Product Change Notification (PCN)

PCN Number	500528	Date Issued	March 07, 2016
Product Family	Please refer to the full part list attachment for details.		
Series	Please refer to the full part list attachment for details.		
Reason for Change	Change to Product		
Change Type Description	This letter is to inform you that changes are being made to the part(s) identified in this Notice. The change will affect the fit, form, function or the appearance of the parts. The pictures below show an example of the possible differences.		
Assessment of Change	Product will be fully qualified before it is shipped. Qualification reports are available upon request.		
Internal Molex Qualification Date	May 02, 2016		
Sample Availability Date (Changed Part)	May 02, 2016		
Planned Implementation Date	August 09, 2016		
Method of Identifying Change	Product made after planned implementation date can contain the change

Before Change

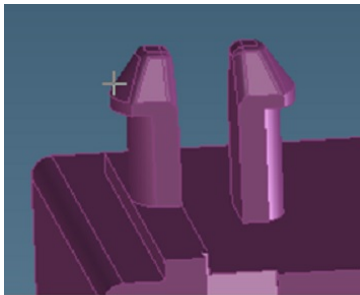
Current product with straight pegs

After Change

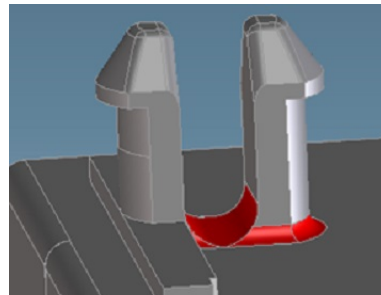
New product with radius (shown in red)
